Access Compliance Report

Public Rights-of-Way

(Curb Ramps)

Intersection ID: 17570	Main Street: RANDOLPH_RD	Cross Street: WOODLARK_LN	Location: S
ADA ID: 2AB17EE588D4	Ramp Type: Perp	Initial Pass/Fail: Fail	Overall Compliance: No
Codes/Mitigation Info/Possible Solution		Field Measurements/Component Compliance	
Severity Score: 33.75

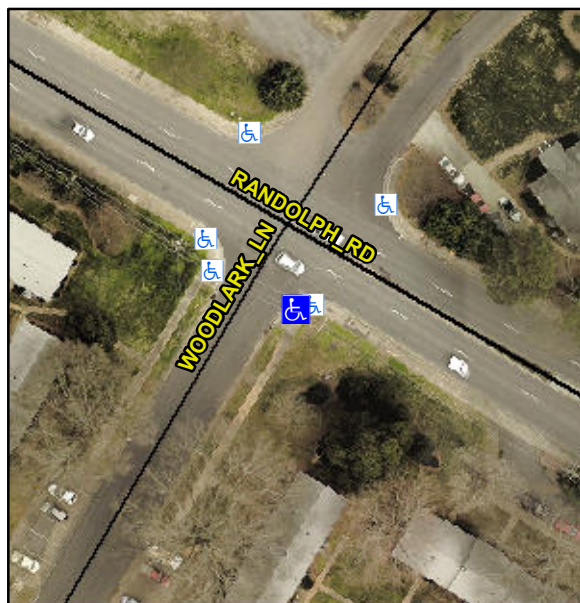
Not Found, R304.5.1, R304.2.2, R304.5.3

Compliance	Description	Data	Compliance	Description	Data
N/A	Ramp Length (in)	72.0	No	Ramp Slope (%)	9.4
No	Ramp Width (in)	36.5	No	Ramp XSlope (%)	5.5
N/A	Flare Type LT	N/A	N/A	Flare Type RT	N/A
N/A	Flare Slope LT (%)	N/A	N/A	Flare Slope RT (%)	N/A
N/A	Flare Traversable LT?	N/A	N/A	Flare Traversable RT?	N/A
N/A	Landing Length (in)	N/A	N/A	DWS Provided?	N/A
N/A	Landing Width (in)	N/A	N/A	DWS Contrast?	N/A
N/A	Landing Slope (%)	N/A	N/A	DWS Length (in)	N/A
N/A	Landing X Slope (%)	N/A	N/A	DWS Full Width?	N/A
N/A	Landing Curb? (Y/N)	N/A	N/A	DWS Offset (in)	N/A
N/A	Shared Landing?	N/A			
N/A	Gutter Ponding?	N/A	N/A	Gutter Slope (%)	N/A
N/A	Gutter Lip Ht (in)	N/A	N/A	Gutter X Slope (%)	N/A
N/A	Painted X Walk1?	No	N/A	Painted X Walk2?	N/A
	X Walk 1 Direction	To NW		X Walk 2 Direction	N/A
N/A	X Walk 1 Width (in)	N/A	N/A	X Walk 2 Width (in)	N/A
	X Walk 1 Slope (%)	1.3		X Walk 2 Slope (%)	N/A
	X Walk 1 X Slope (%)	4.2		X Walk 2 X Slope (%)	N/A

Remove & Replace Entire Ramp.
